FIFTH REPORT  
OF THE  
TMI-2 Technical Assistance and Advisory Group (TAAG)

April 1, 1983

This report covers the TAAG activities during the period of time from December 1, 1982, to April 1, 1983. In a letter, dated February 9, 1983, Mr. B. K. Kanga, Director, TMI-2, requested that TAAG address the following technical matters:

**FIGURE 1**  
**E1 282'6" CESIUM DIFFUSION MODEL**

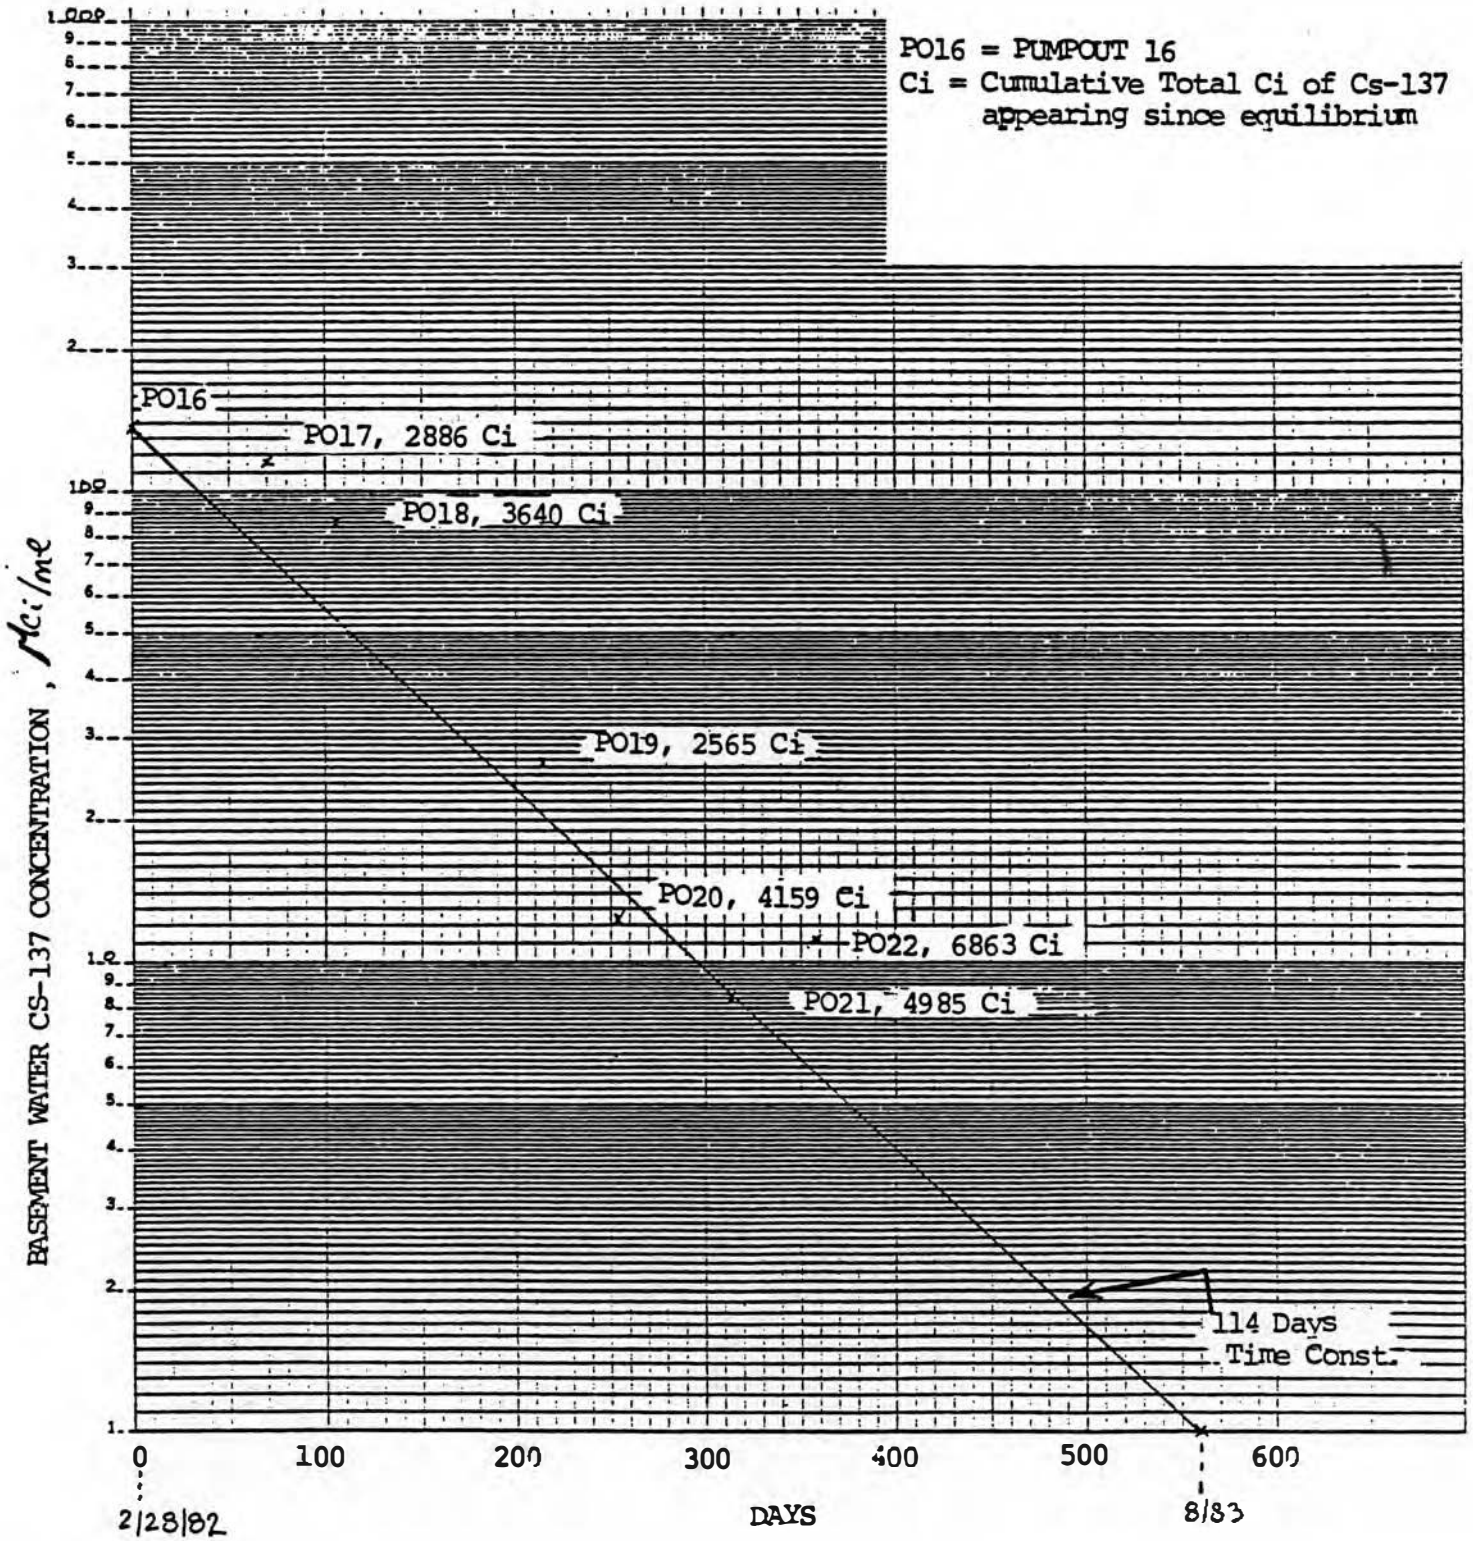
A diffusion or leaching model is represented by Figure 1 which shows the Cs-137 concentrations during each of the pumpouts of the reactor building basement. Zero time in this figure is shown at the time of the 16th pumpout in February 1982. At this time, the Cesium concentration in the reactor building basement water was 138 uCi/ml. Pumpouts prior to this time had not substantially reduced the basement Cesium concentration. A relatively long-term equilibrium is therefore postulated to have existed at time zero. Subsequent to time zero, the reactor building basement was pumped out six times (and is continuing to be refilled and pumped out).

The curve labeled on Figure 1 as "The 114-day time constant" represents the concentrations expected if the pumpout process continues. Some estimate may be made of the time when the Cs-137 concentration may be reducible to approximately 1 uCi/ml. This time is August 1983, assuming that refilling and draining of the basement continue approximately as has been done for pumpouts 17 through 22.

E1 282'6" CESIUM DILUTION MODEL

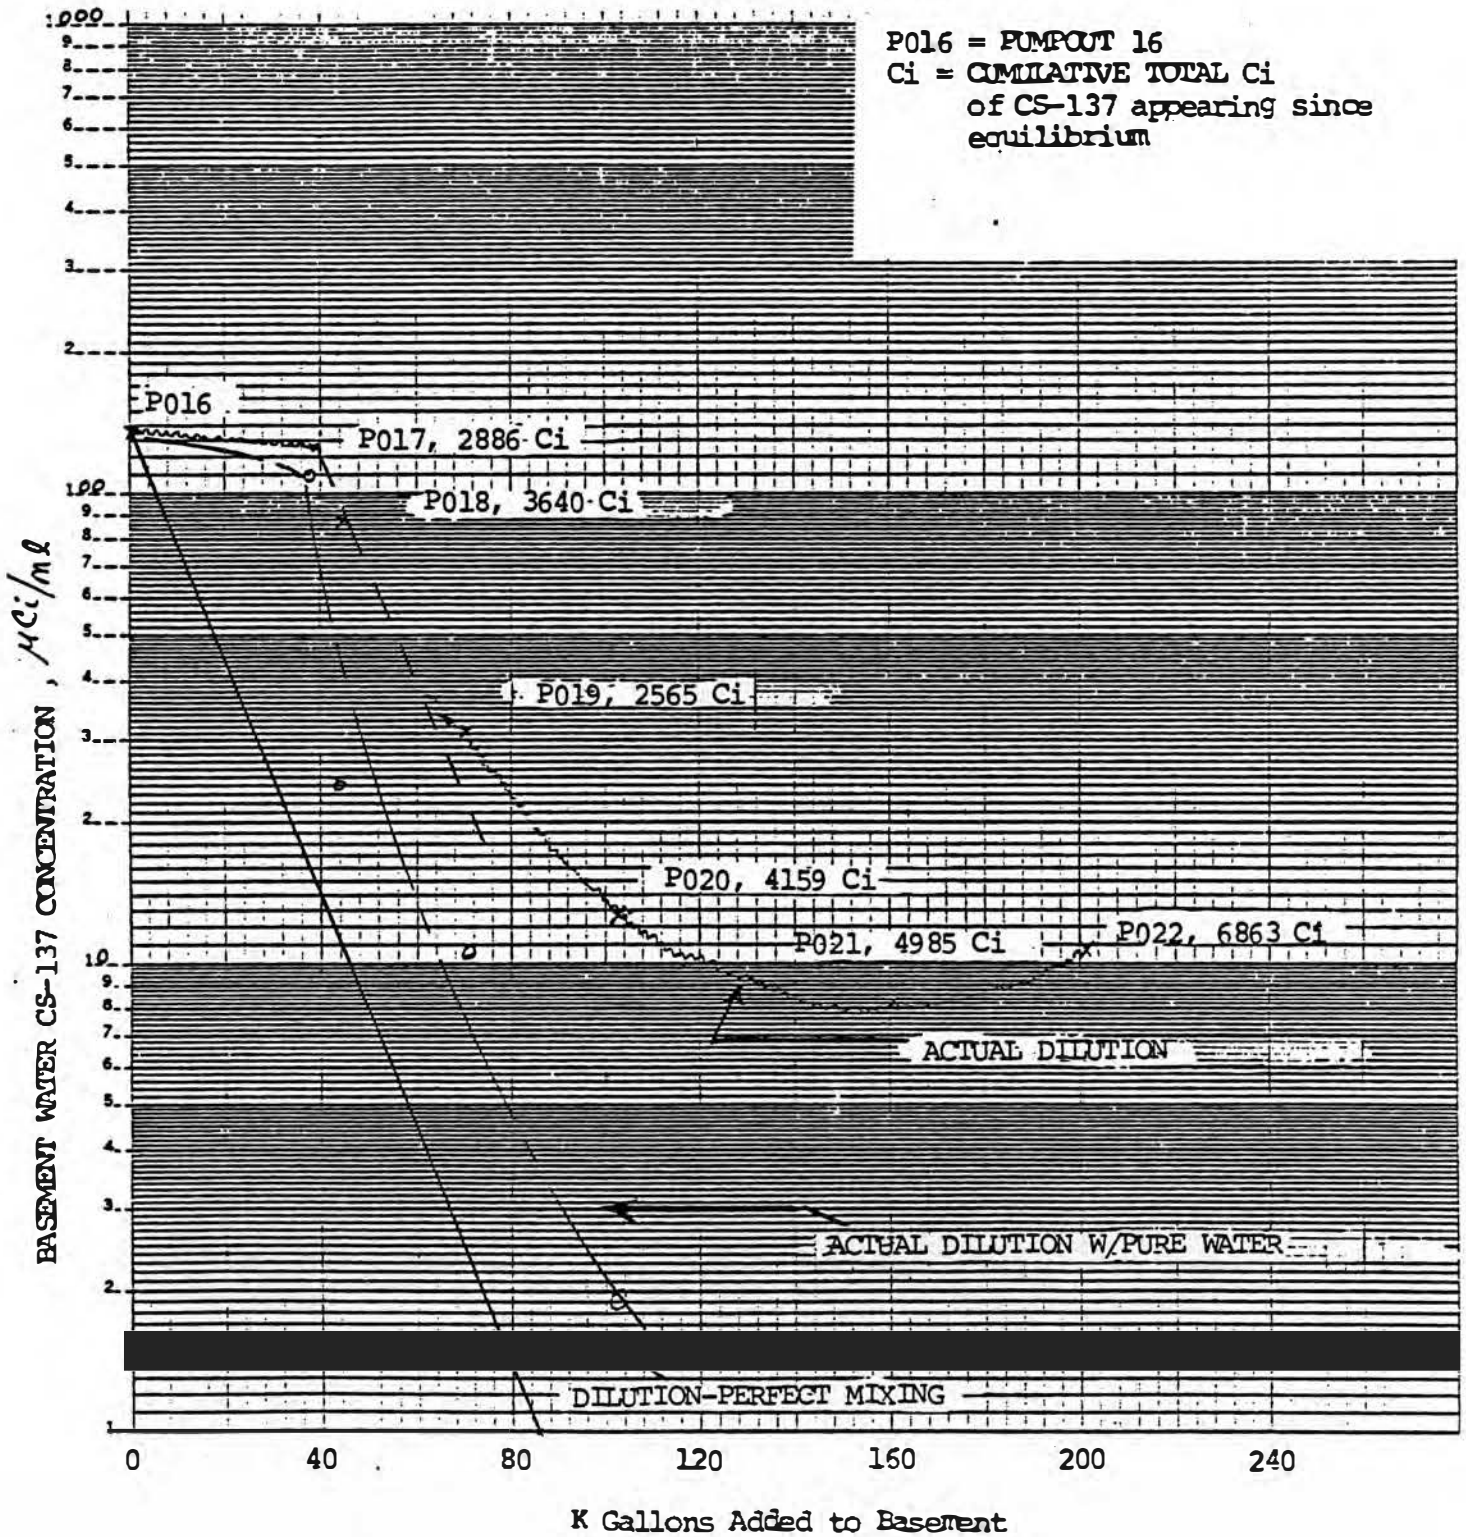
The second interpretation is represented by Figure 2 which shows the basement water concentration data plotted against the number of gallons of water that have been added to and removed from the basement since equilibrium existed. If a simple dilution process were operating, the data should approximately fit the line labeled "Dilution - Perfect Mixing". Departure of the data from this line indicates that the process is not a simple dilution. Figure 2 also shows by the dotted line a portion of the process that may have been dominated by dilution.

FIGURE 1  
 REACTOR BUILDING PURGE AND PURIFICATION SYSTEM

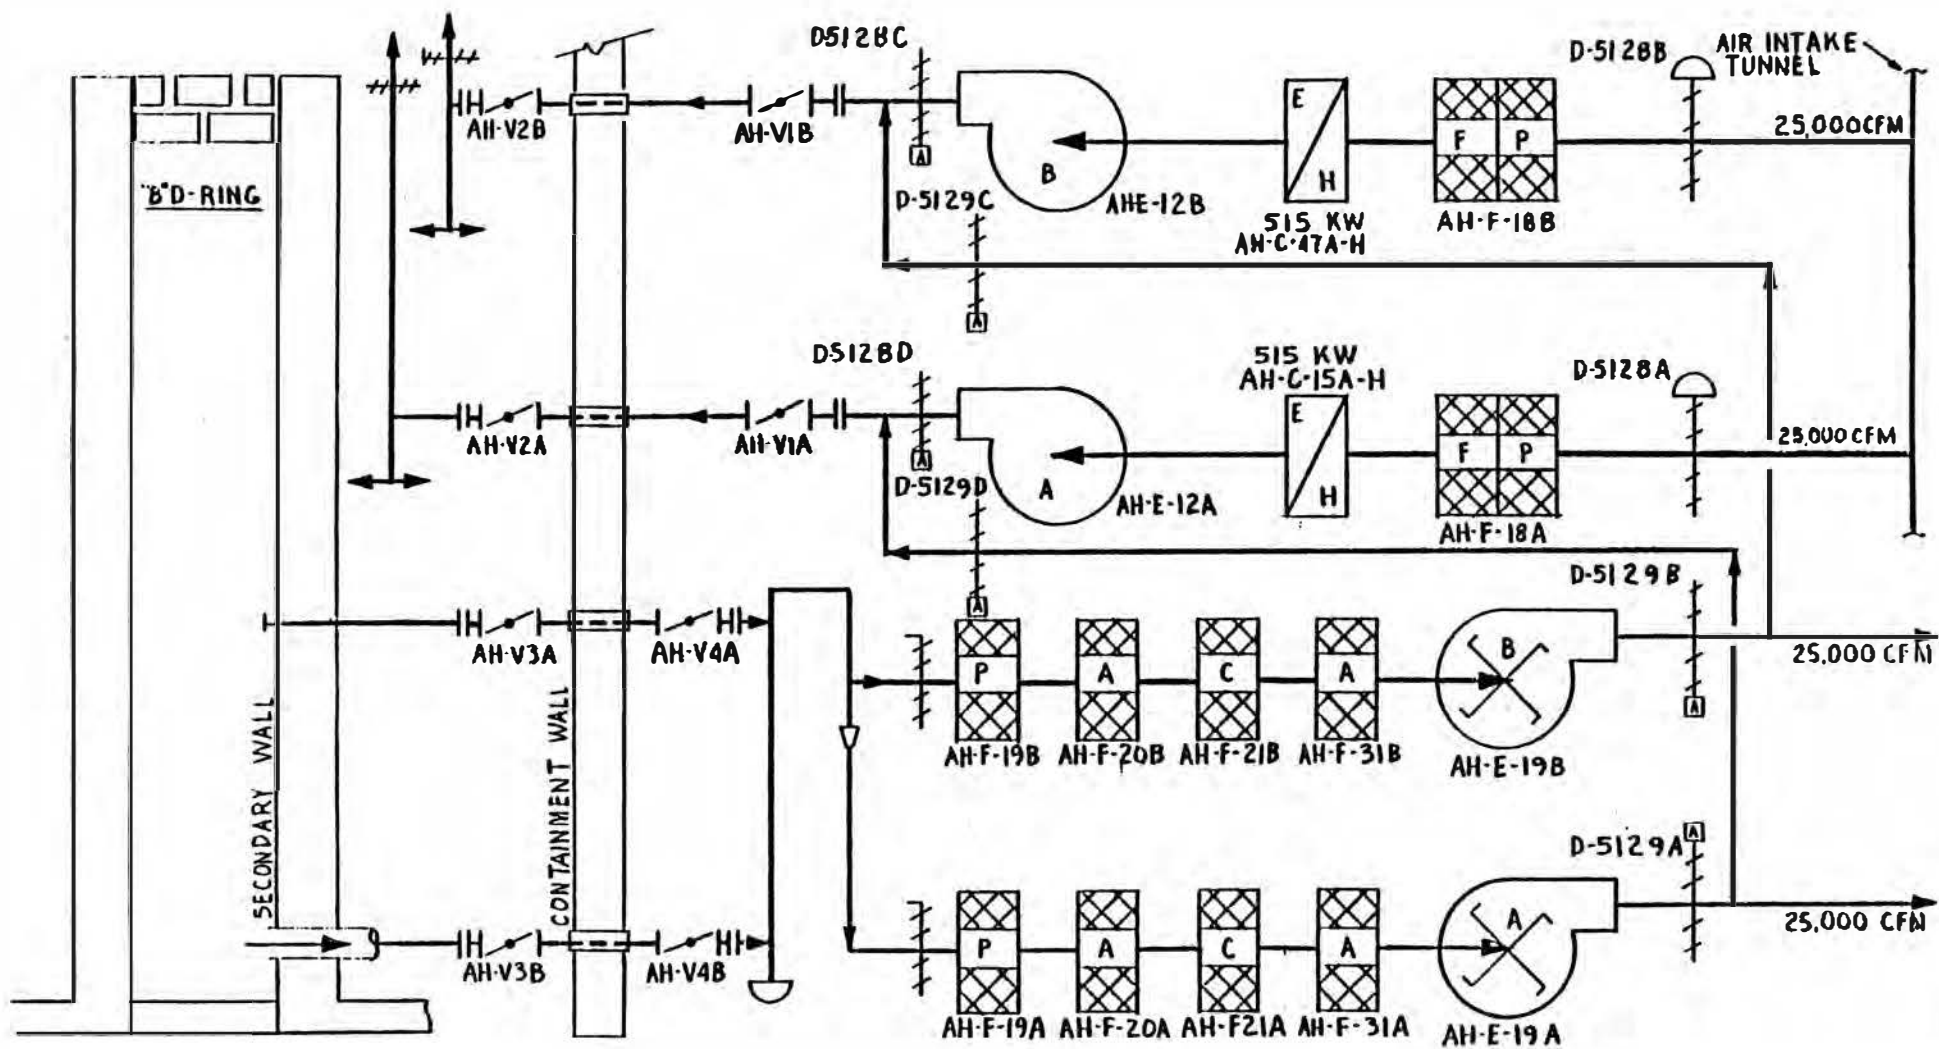
1. Dampers 5128A, B, C, and D would be closed. (See Figure 1.)
2. Valves AH-V-1A, 1B, 2A, and 2B would be opened.
3. The purge supply systems would be off. Actions 1, 2 and 3 would be initiated from the control room.
4. Two of four WG-1 trains would operate for 60,000 CFM. The new isolation dampers would be opened. These actions would be initiated from the WG-1 control panel in the turbine building.
5. One or two existing purge exhaust trains would be operated for a total of 85,000 CFM or 110,000 CFM exhaust. These fans are started from the control room.

CALCULATED HEAD DOSE RATES  
UNIFORM CONTAMINATION OF HEAD AND SUPPORT TUBES

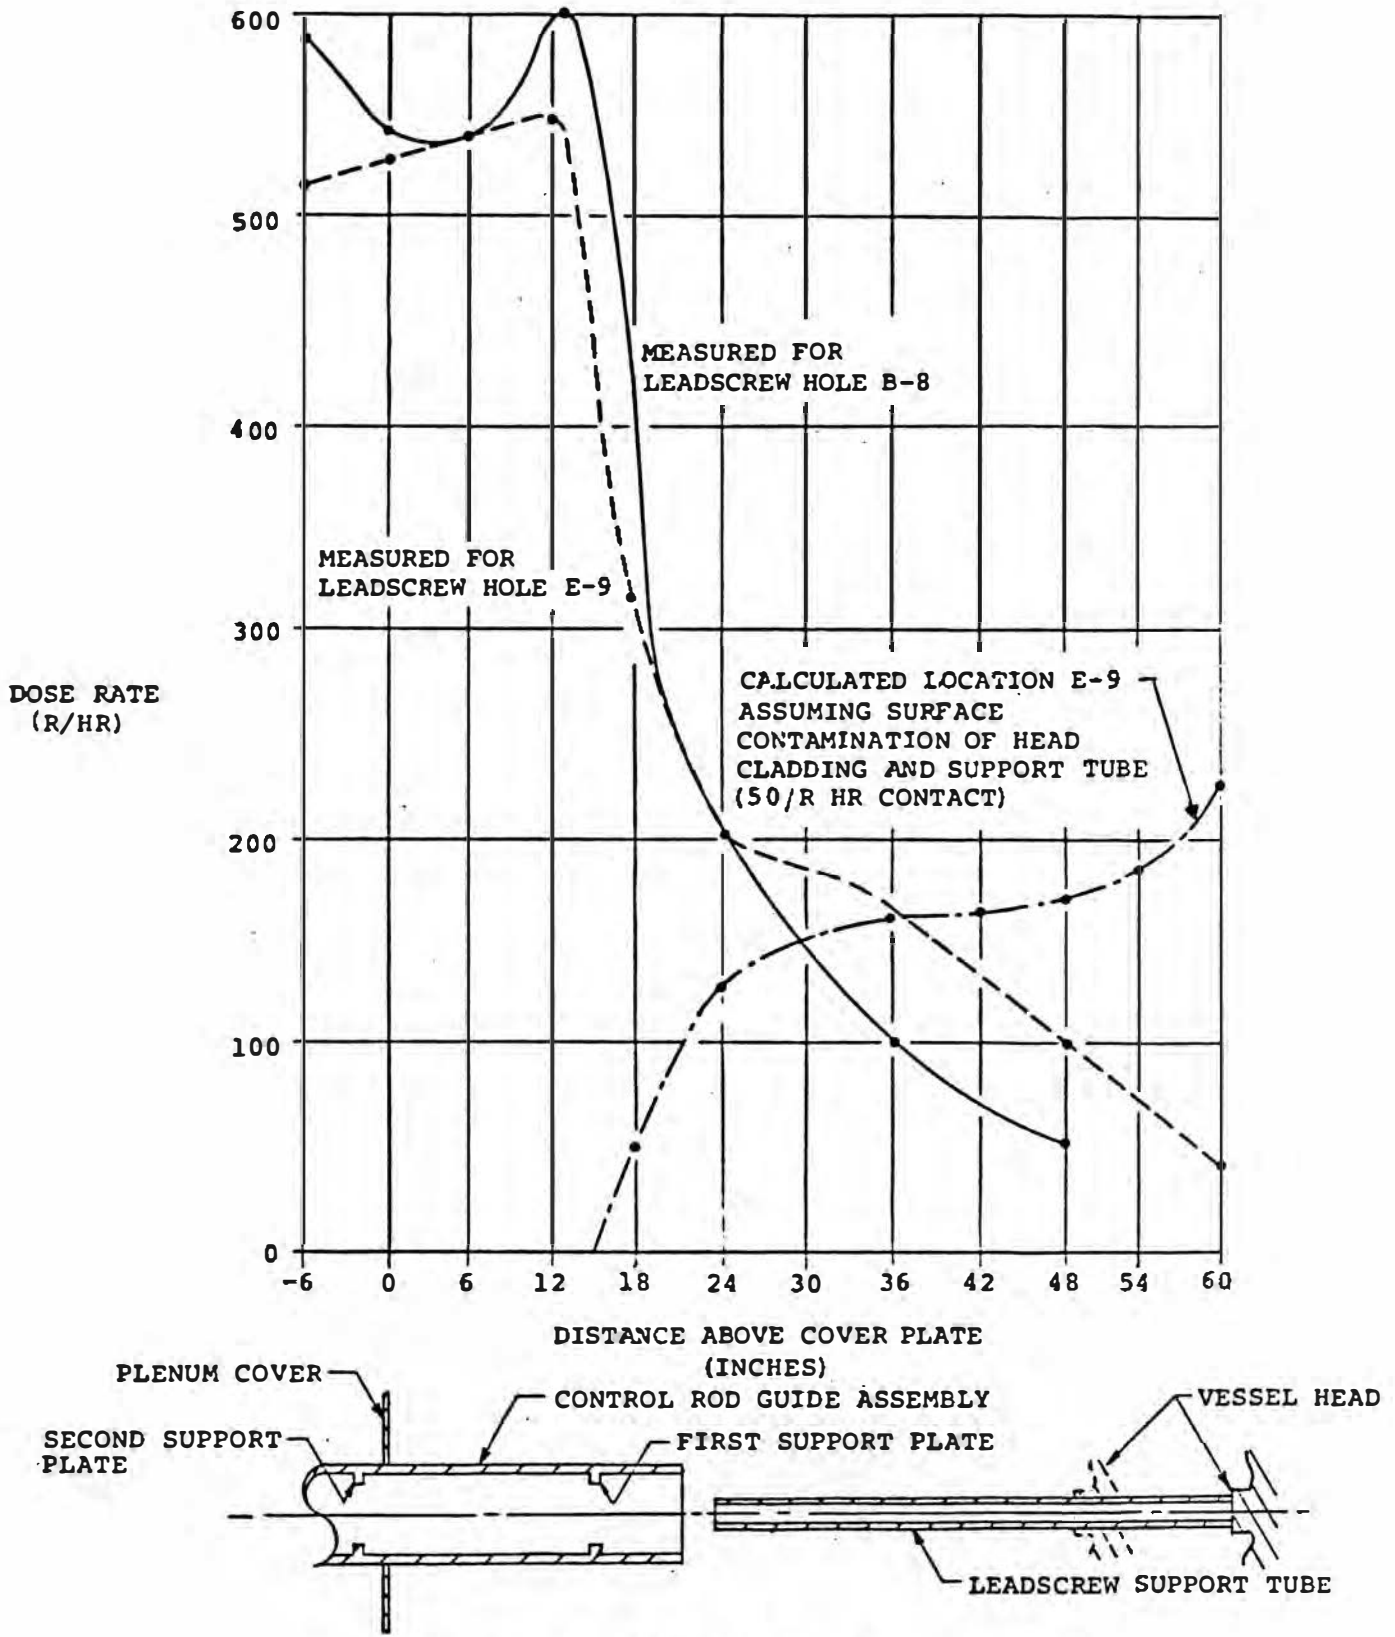
- c. Reactor vessel head component dose rates may be characterized as follows:
- The inside surface of the reactor vessel head is not significantly contaminated. This can be seen from Figure 5, which shows that if the head were contaminated to the same degree as removed leadscrews, (i.e., about 50 r/hr at contact), a significant dose rate peak would have been measured at the inside surface of the head. No such peak was observed.

In the first case, shown in Figure 5, it is assumed that surface contamination is present on the inside surface of the reactor vessel head, and also on the inside and outside surfaces of the

leadscrew support tube. As shown in Figure 5, surface contamination on the head inside surface of the same magnitude as on the support tube would cause a dose rate peak near the head surface. Such a peak was not measured. Accordingly, it appears that contamination of the head inside surface is small with respect to contamination on the support tube surfaces.
